IloT Product End-of-Life Notice

End of Life, Last Time Buy and Replacement Announcement

For immediately release, Advantech is announcing the End of Life (EOL) of **ADAM-4015-E**. The relative replacing models are as below list. Customers who had purchased this Part Number either to purchase any additional rules or migrate to the new replacement models if possible before the EOL's shipment date.

1. Remove INIT* pin

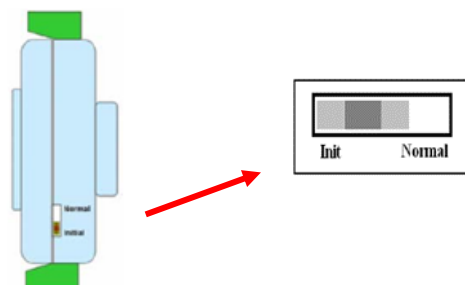
Impact	New version
Pin assignment	Backward compatible, Remove INIT* pin
Hardware spec	Add Initial switch
FW	New version A 4.02 or later
Utility	Adam/Apax .NET Utility 2.6.00 B15 later version

2. Add Initial switch
